Appendix 2: Consented Scheme - DAS statements fact checked

DAS diagram (right)

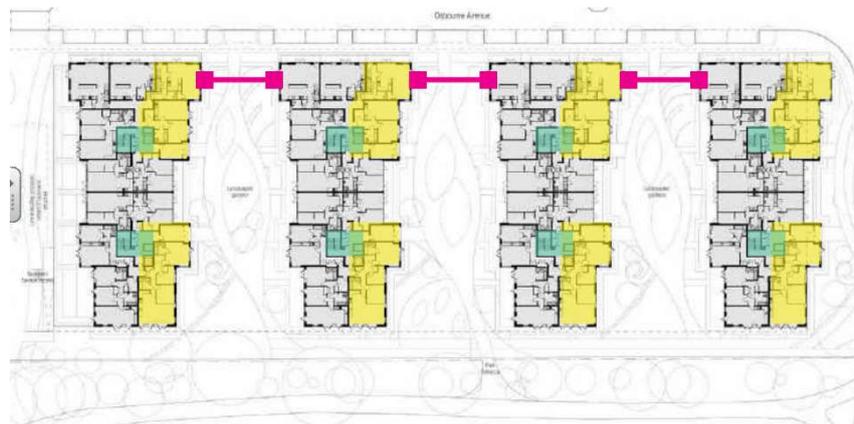
- 1) **The developer states, ‘Whilst scheme [sic] provides high levels of dual aspect units, many remain predominantly north facing.’**
Reality: only 16 flats in total (4.3% of 371) are North facing

This statement is inaccurate and misleading. There are only 4 North facing flats per block so 16 in total. There are no other single aspect *North* facing units in this scheme. **As a percentage of 371 this represents just 4.3%.** Additional studies were carried out to ensure the very small number of North facing units achieved excellent levels of daylight. They were not at risk of overheating.

Further analysis in the DAS is also misleading. In particular, it highlights dual aspect N/W and N/E facing flats at the ends of each block.

This inaccurately shows large areas of what the developer believes to be north facing flats, highlighted in yellow. Only one floor plan has been used – whereas, in fact, floor plans vary and step back on higher floors. 75% of the highlighted area is actually showing dual aspect flats, not single aspect.

Consented scheme (right)

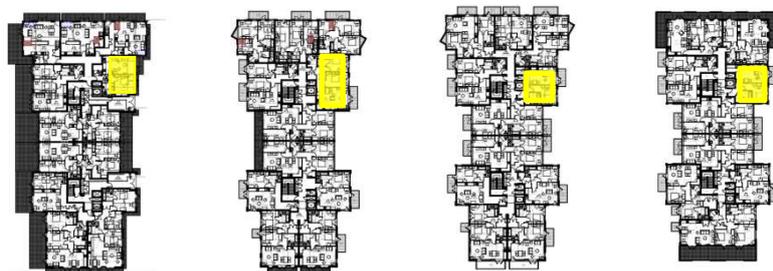
These show that there are actually only four North facing flats/block (shaded yellow)

GLA comments on the current application state that, ‘North facing single aspect units, which **contain three or more bedrooms** or are exposed to significant noise impacts should be avoided. North facing flats in the finger blocks are either one bed (3 /block) or 2 bed (1/block). Therefore, the consented scheme is compliant with GLA comments whereas the proposed scheme has single aspect units exposed to significant noise impacts.

Flats in North Finchley (left)

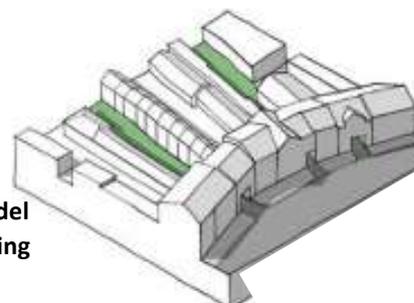
This statement is subjective and misleading. However, it presupposes that buildings on this site *should* be suburban in form – even though the developer seems intent on justifying an ‘urban’ scheme.

It is not uncommon to build perpendicular to a road. A good example is the three storey 30s flat block in North Finchley (below). In fact, with the wider ‘front’ part addressing the road, it is very similar to blocks in the consented scheme.

In the National Model Design Code, various recognized built forms, considered as good models for new development, are illustrated which *‘should be adjusted in response to local character and to the area type in which the street sits’*. The finger blocks reinterpret the example of ‘burgage’ courts. By contrast, there is nothing in the Design Code which relates to the repetitive and regimented layout which the developer has adopted.

Consented scheme: Block A and part of the basement plan

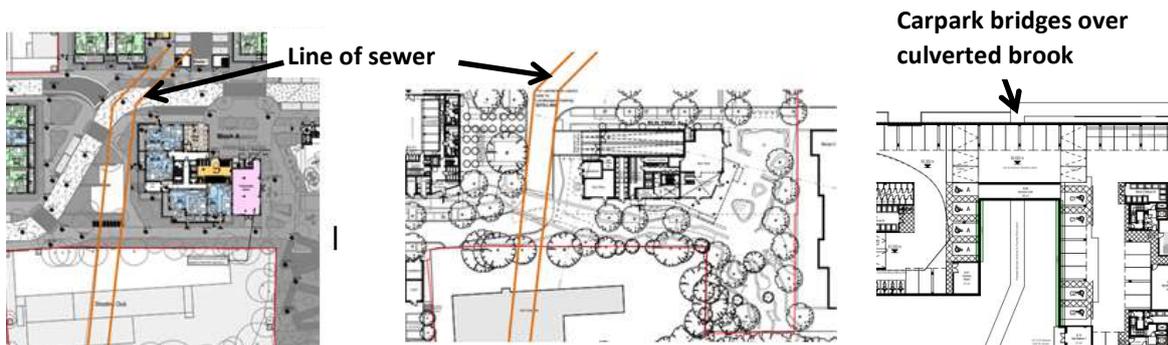
The developer states, ‘Blocks A and B floor plates are compromised by below ground constraints.’

Reality: consented scheme took full account of below ground constraints

This statement is inaccurate and misleading: the architects for the consented scheme took full account of below ground site constraints as noted in their DAS:

- Block B is designed so that there are no footings over the easement. At ground floor, this is a parking area.
- Block A floorplate fits nicely between the sewer and the culvert to Pymmes Brook (below). The original underground carpark proposal bridged over the culvert to access the main parking area beneath the finger blocks. Omitting this represents a cost saving for the developer but has a detrimental effect on the design.

The basement plan (far right) shows that a bridge over the culvert to Pymmes Brook was originally proposed to connect parking under Block A with the main area.

Proposed scheme: seven storey apartment blocks dominate the park. Set-backs occur only on the shorter North/South elevations

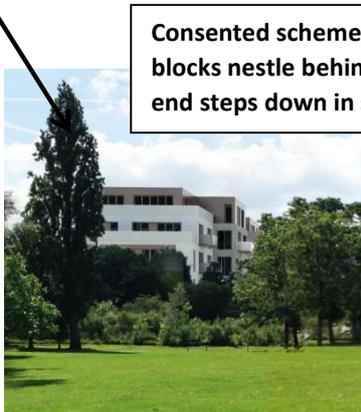
This statement is subjective and misleading. Assuming that it refers to apartment buildings in the current proposal, visualisations (below) of the two schemes suggest strongly that the complexity of the massing in the consented scheme is far more effective in breaking down the mass of the buildings.

The current proposal ignores design guidelines in the London Plan relating to the need to mediate the scale (using set-backs) adjacent to public open spaces. Flat facades up to seven storeys in height dominate external spaces, for example the communal gardens.

Proposed scheme (above): flat, seven storey facades to B1, C1 and D1, with no three dimensional modelling, overlook the communal gardens.

Using the existing trees as a reference, the over-dominant massing of the current application is clear in comparison to the consented scheme

COMPARISON OF LANDSCAPING IN THE CONSENTED AND PROPOSED SCHEMES

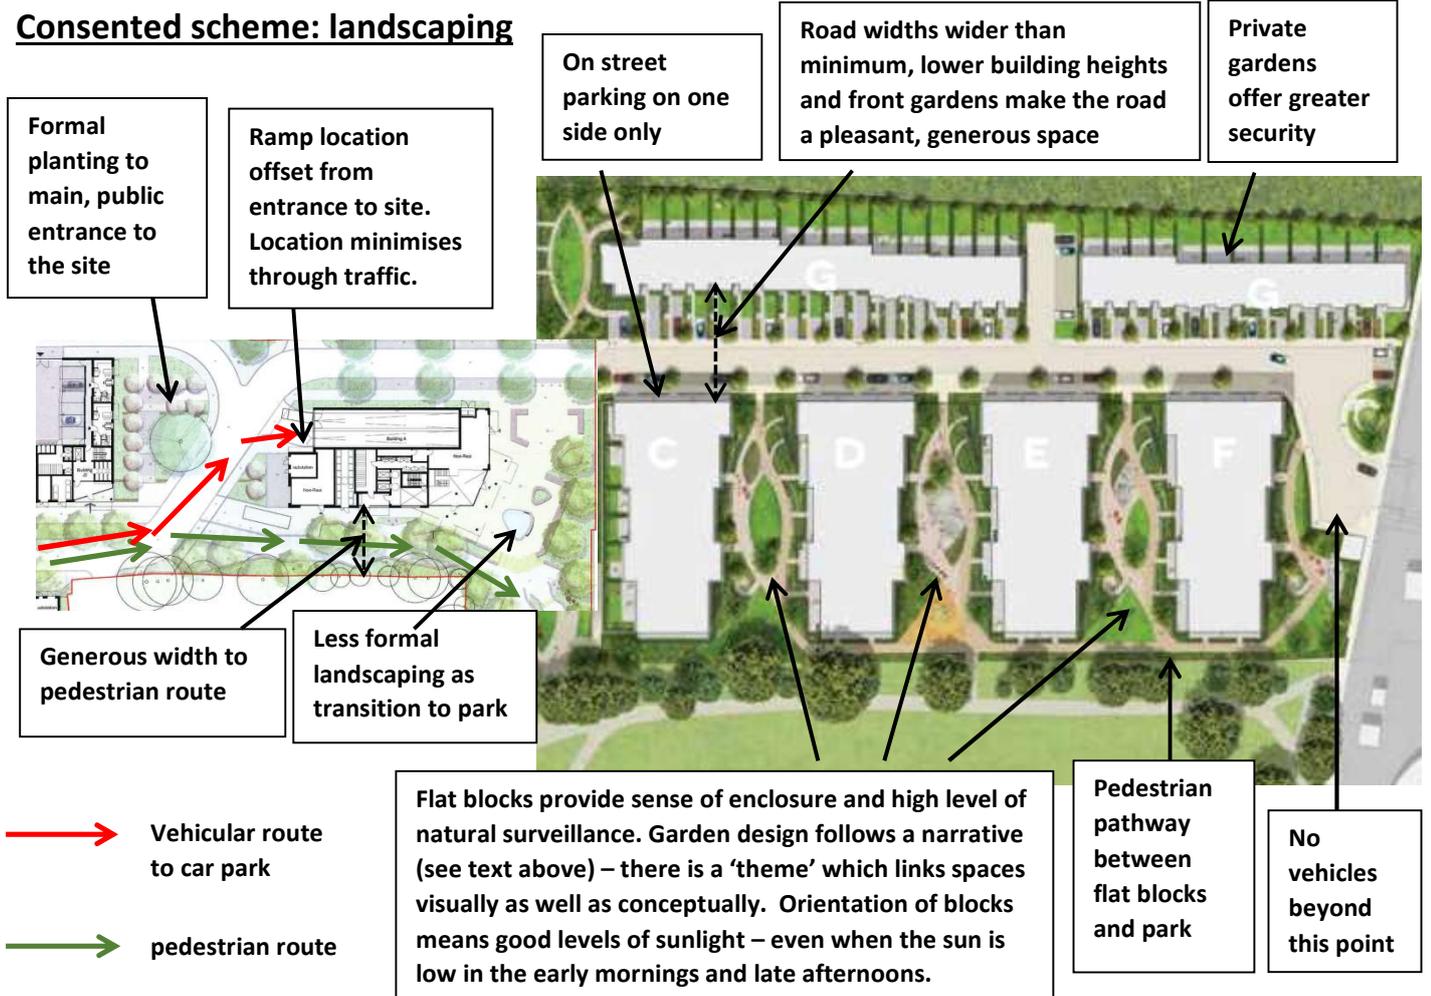
This statement is subjective and misleading. As discussed (no.10 above), the hierarchy of public and private spaces in the consented scheme has been much more carefully thought through, from a more formal public square at the entrance of the site, through increasingly informal landscaping on the public pedestrian route (Pymmes Square) and in the semi private gardens between finger blocks. Houses along the western boundary have their own private gardens, increasing security in this area.

By contrast, the lack of definition between public and private is one of the main design issues in the proposed scheme, the result of a flawed layout strategy (see Section 5 in the main report). This has also been commented on by the GLA (see Appendix 1). Left-over spaces between blocks are utilised for parking, playgrounds, communal gardens, turning heads for vehicles or ramped access to the basement carpark. There is little evidence of place making or hierarchy of public and private in the external spaces in this scheme.
